# **CITY OF NEWBURGH GAC TREATMENT SYSTEM AT WASHINGTON LAKE FILTRATION PLANT**

## **ADDENDUM No. 1**

**TO CONTRACT NOS. D010308, D010309, D010310, D010326**

**Arcadis CE, Inc.  
855 Route 146, Suite 210  
Clifton Park, NY 12065**

SK1-C05-ADD1

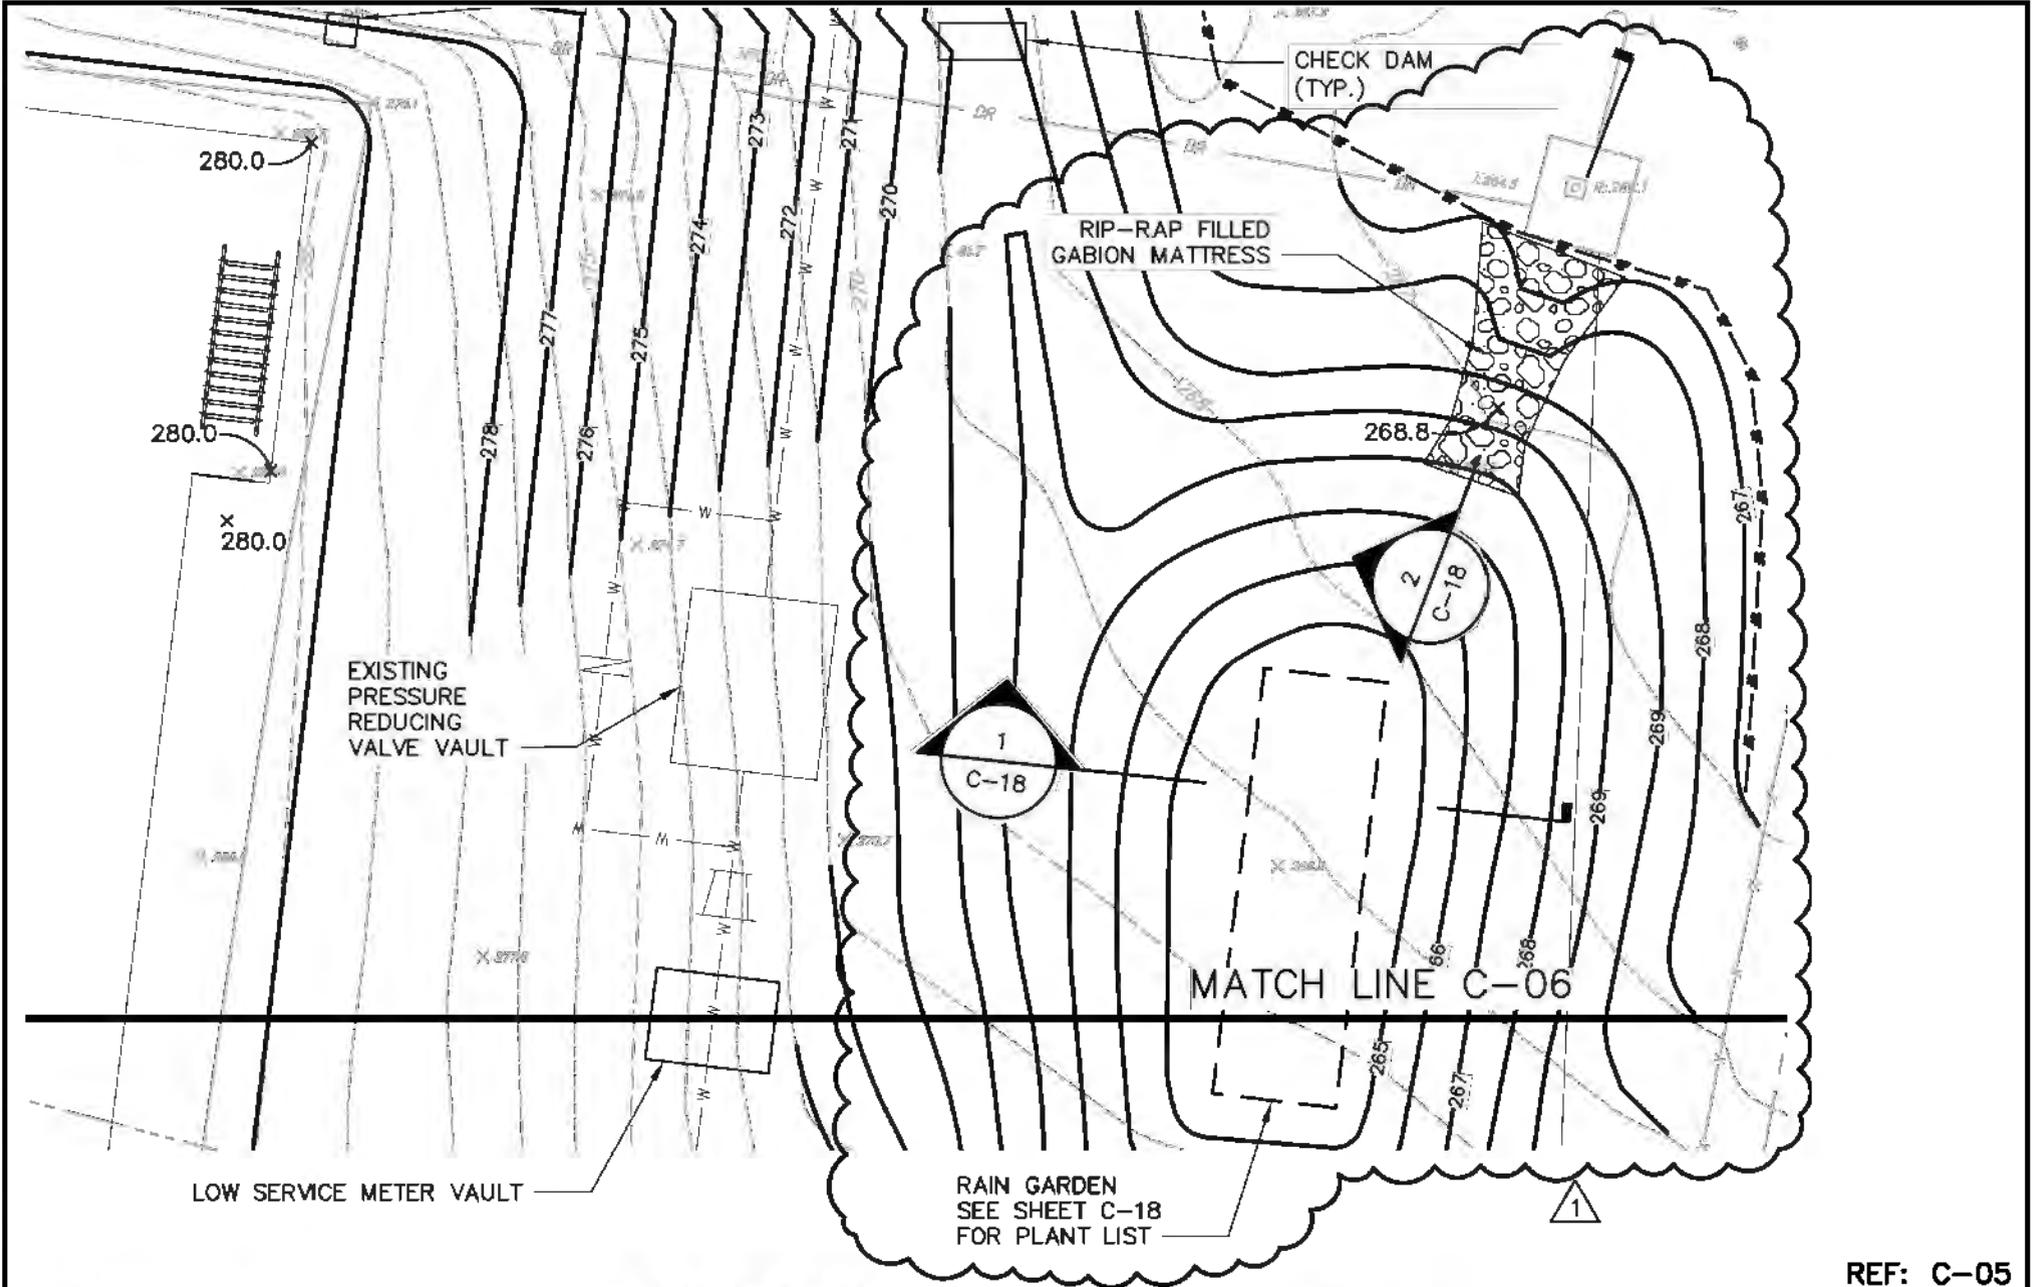
35. **Drawing C-05:** Add revisions as shown on Figure SK1-C05-ADD1 as attached.
36. **Drawing C-06:** Add revision as shown on Figure SK1-C06-ADD1 as attached.

SK1-C08-ADD1

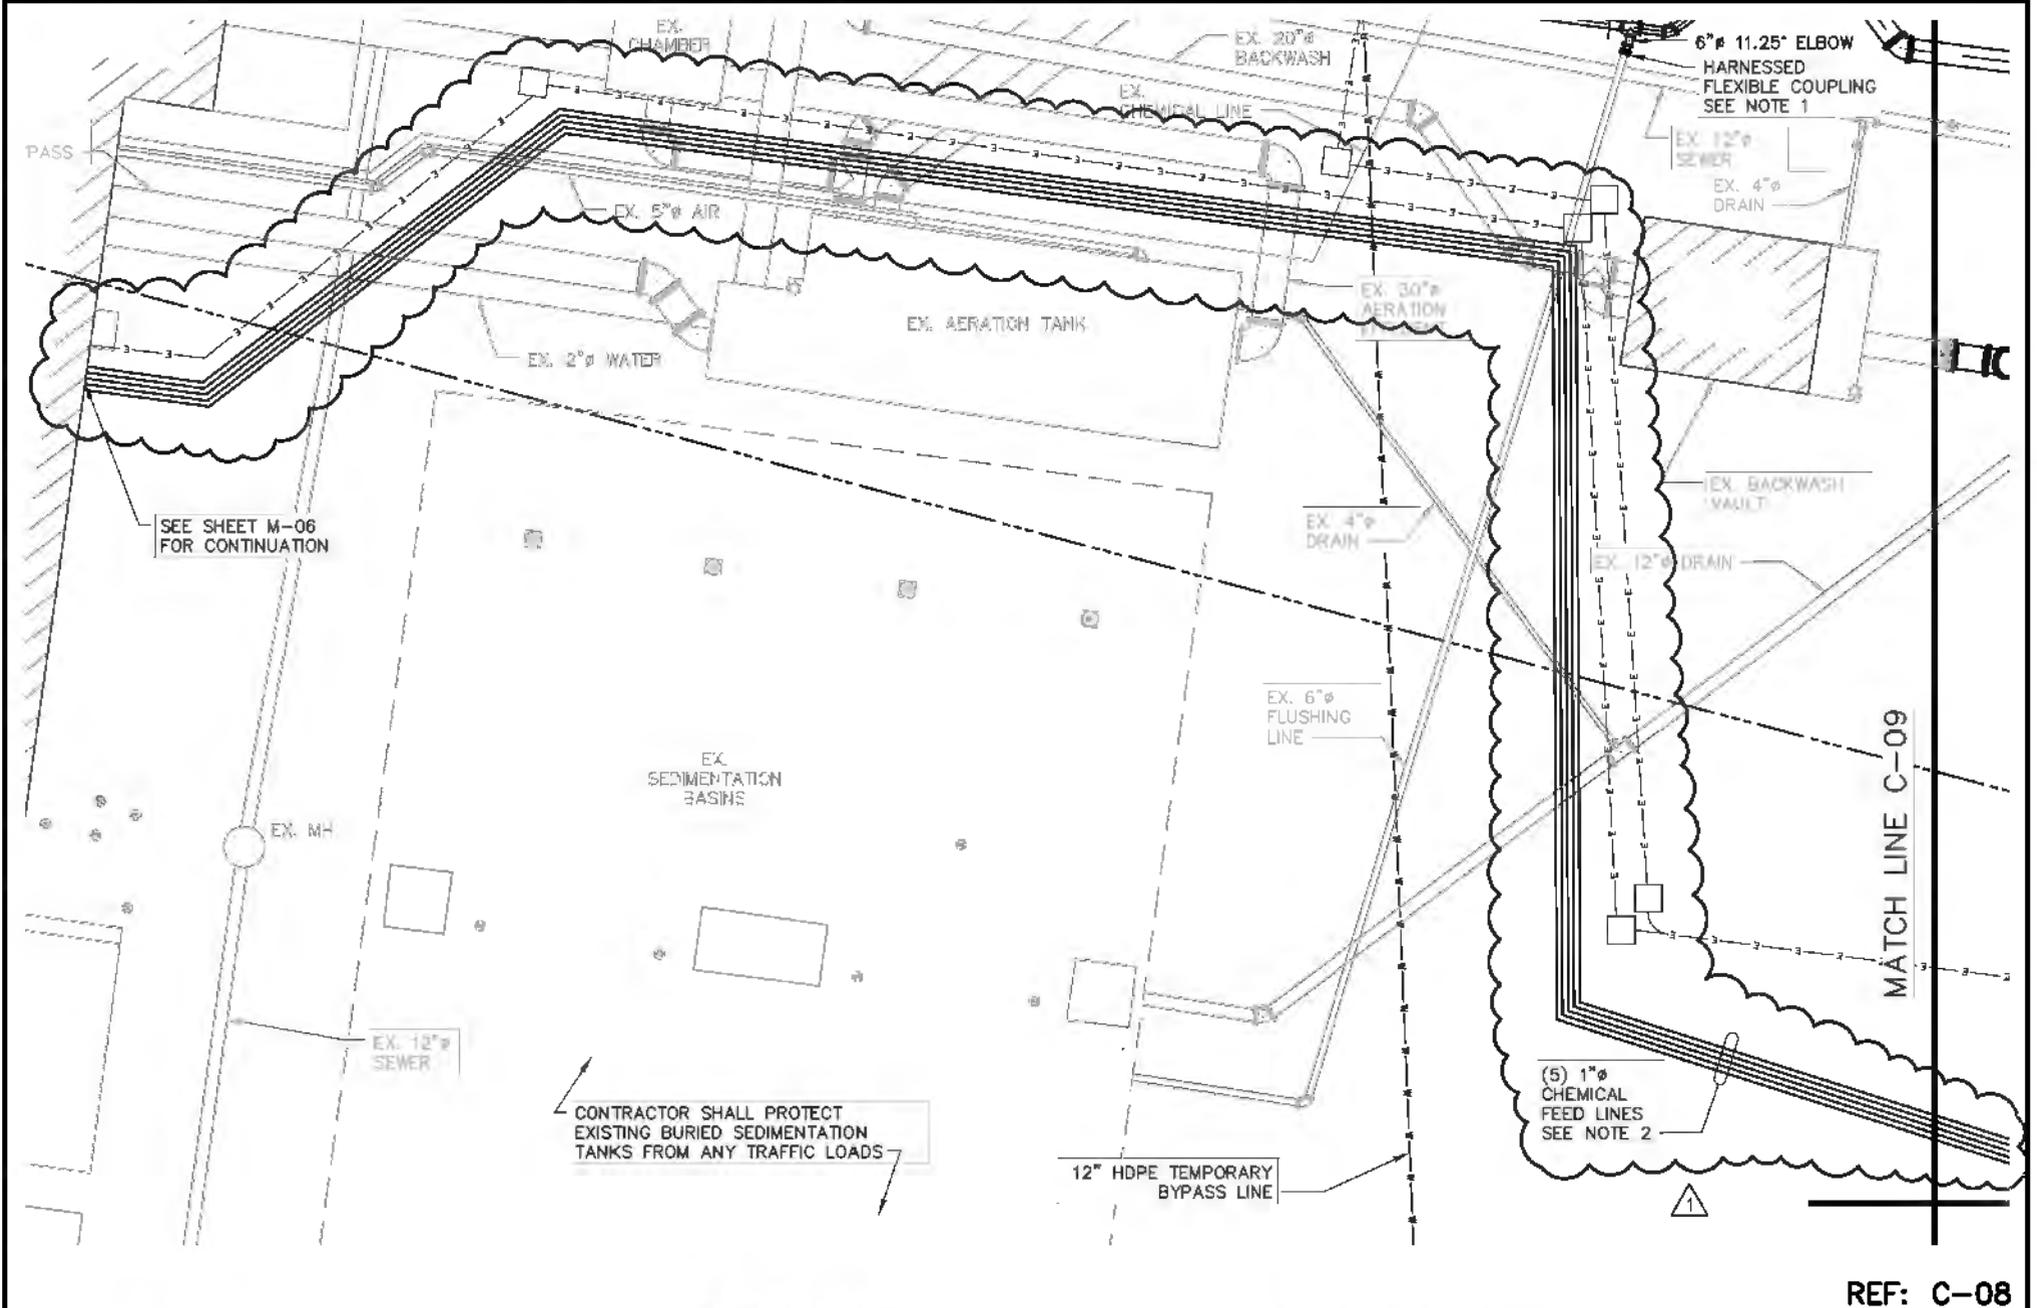
37. **Drawing C-06:** Add revision as shown on Figure SK2-C06-ADD1 as attached.
38. **Drawing C-08:** Add revision as shown on Figure SK1-C08-ADD1 as attached.

SK1-C09-ADD1

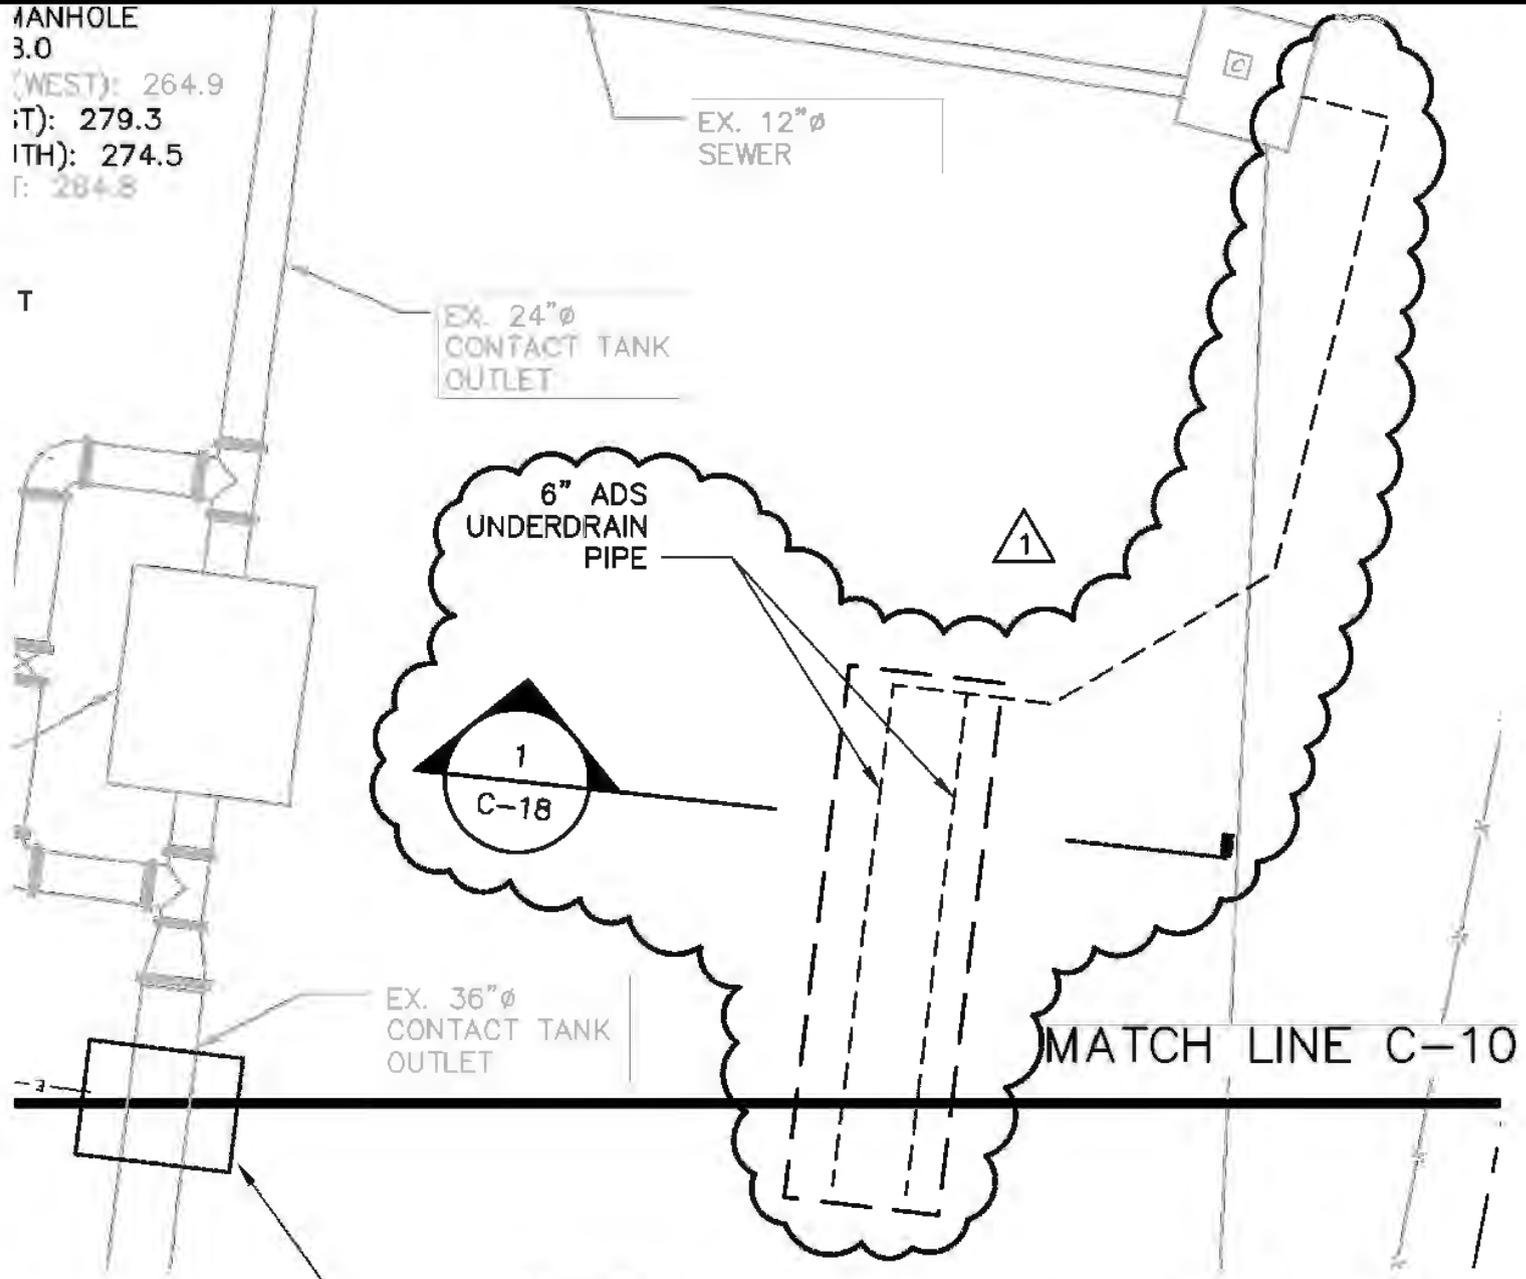
39. **Drawing C-09:** Add revision as shown on Figure SK1-C09-ADD1 as attached.
40. **Drawing C-09:** Add revision as shown on Figure SK2-C09-ADD1 as attached.

SK2-C10-ADD1

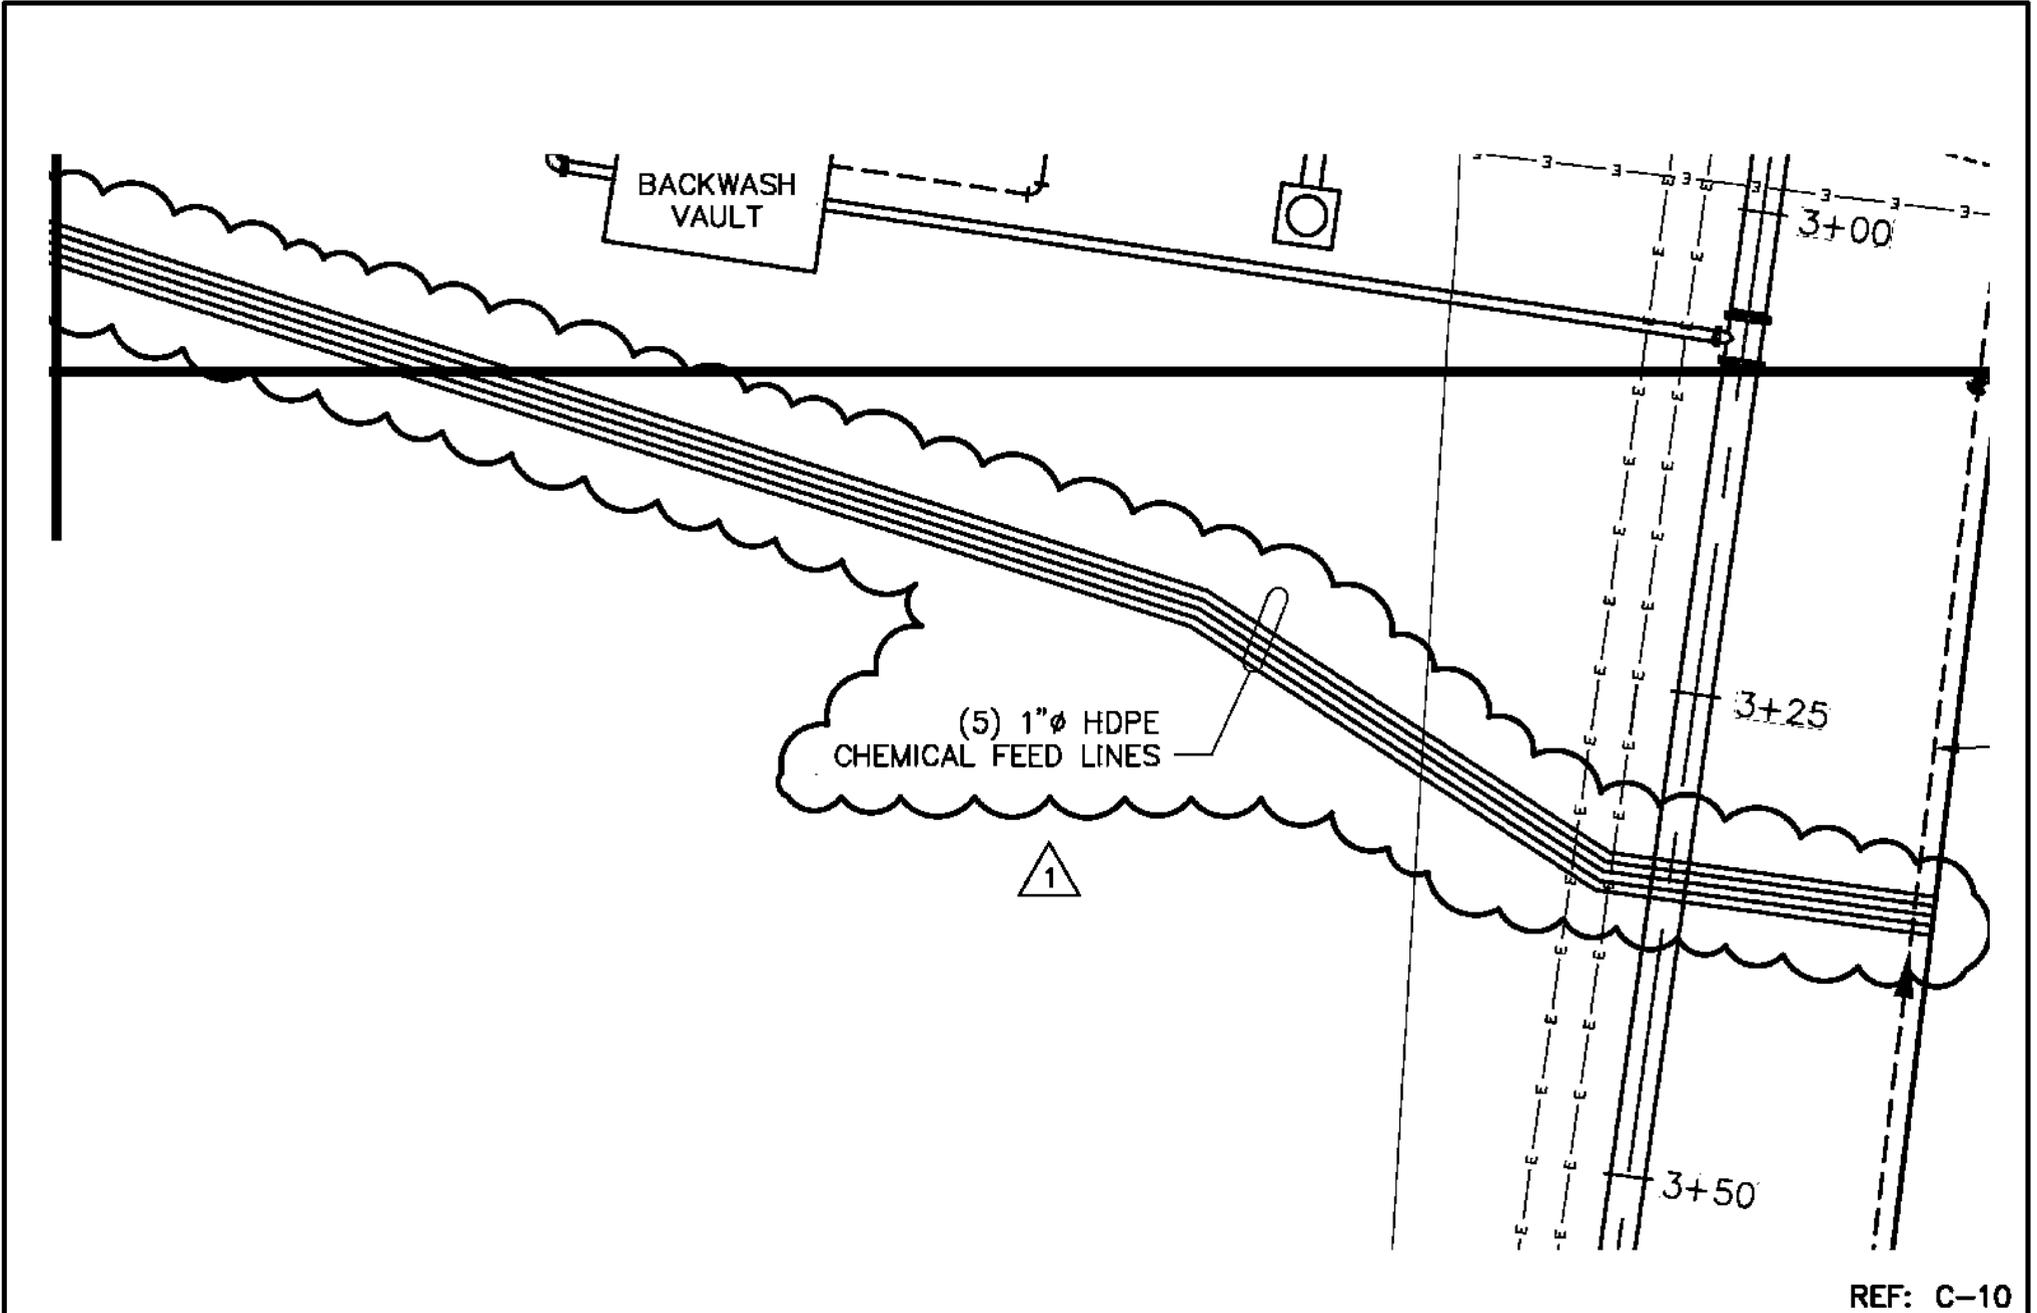
43. **Drawing C-10:** Add revision as shown on Figure SK1-C10-ADD1 as attached.
44. **Drawing C-10:** Add revision as shown on Figure SK2-C10-ADD1 as attached.

<p>ARCADIS Design &amp; Consultancy for natural and built assets</p>	<p>CITY OF NEWBURGH</p> <p><b>GAC TREATMENT SYSTEM AT WASHINGTON LAKE FILTRATION PLANT</b></p>	<p>CIVIL <b>DETAILS III</b></p> <p>NOT TO SCALE</p>	NOVEMBER 2016
			SK1-C15-ADD1

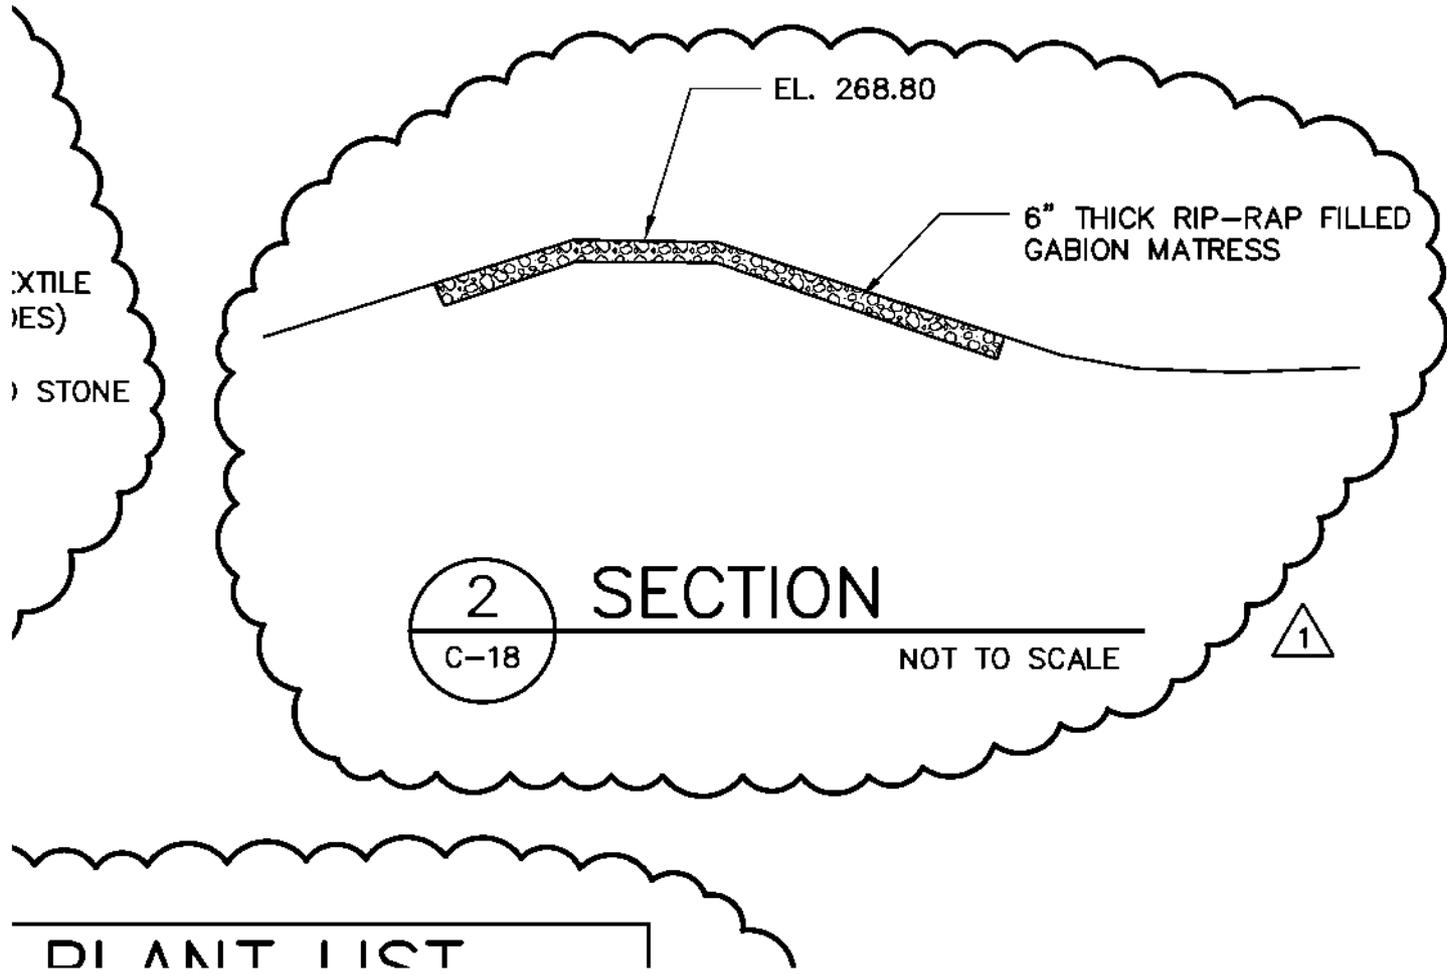
45. **Drawing C-10:** Add revision as shown on Figure SK3-C10-ADD1 as attached.
46. **Drawing C-15:** Add revision as shown on Figure SK1-C15-ADD1 as attached.
